SAFETY EVALUATION BY THE OFFICE OF NUCLEAR REACTOR REGULATION
RELATED TO AMENDMENT NO. 166 TO FACILITY OPERATING LICENSE NPF-9
AND AMENDMENT NO. 148 TO FACILITY OPERATING LICENSE NPF-17

DUKE POWER COMPANY

MCGUIRE NUCLEAR STATION, UNITS 1 AND 2

DOCKET NOS. 50-369 AND 50-370

Figure 3.4-2

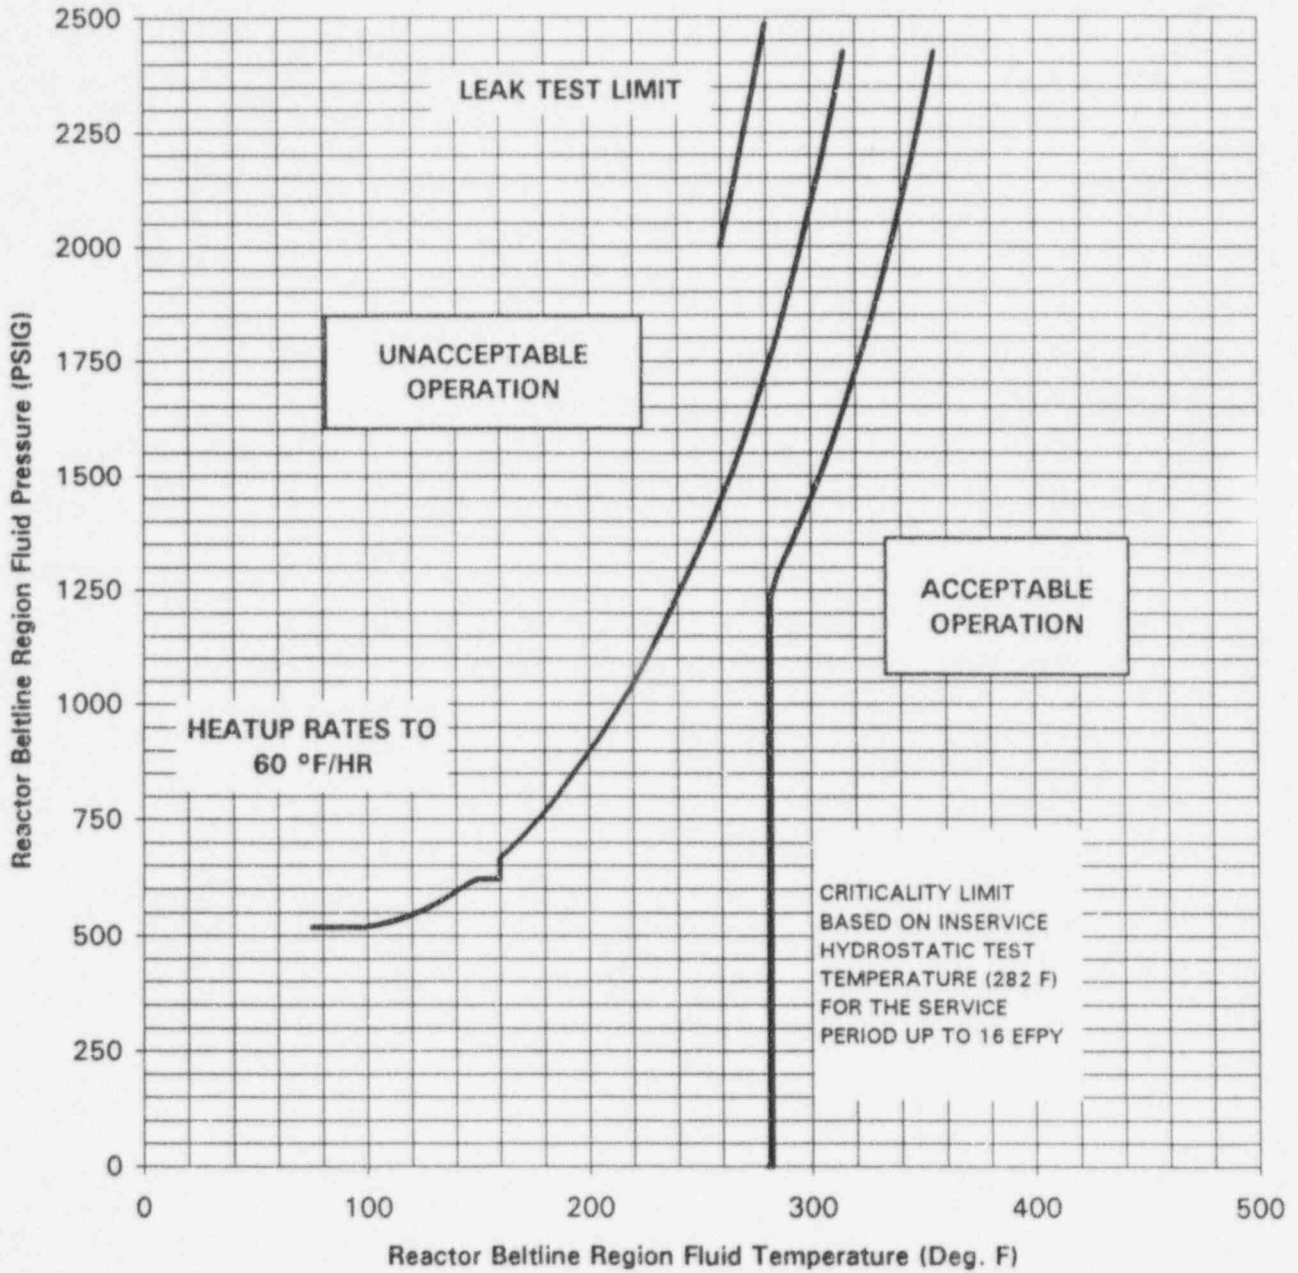
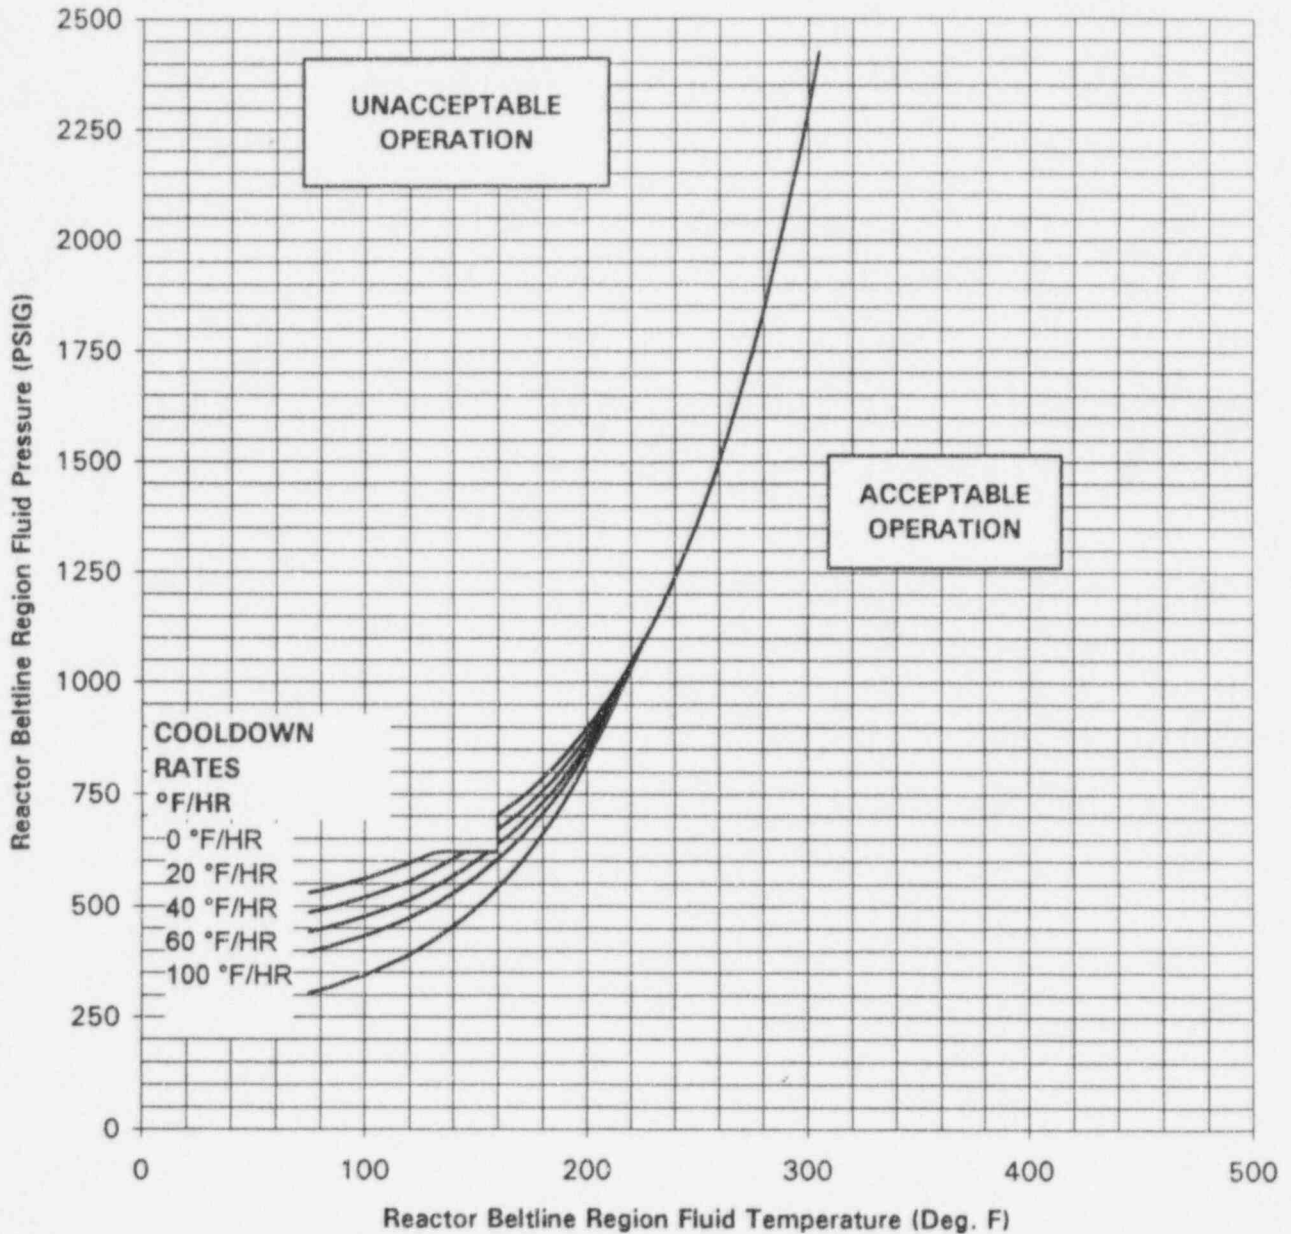
The Limiting Condition for Operation and Surveillance Requirements for the Pressure/Temperature limits list four figures for the heatup and cooldown curves. Figure 3.4-2 and 3.4-4 on current TS pages 3/4 4-31 and 3/4 4-33 are applicable to Unit 1 only. Figures 3.4-3 and 3.4-5 on current TS pages 3/4 4-32 and 3/4 4-34 are applicable to Unit 2 only. These figures will be renumbered as Figure 3.4-2 and Figure 3.4-3 on proposed pages 3/4 4-30 and 3/4 4-31 and located in the unit-specific volume to which they apply. The index pages will also reflect the corrected figure number. The text notations will indicate the same.
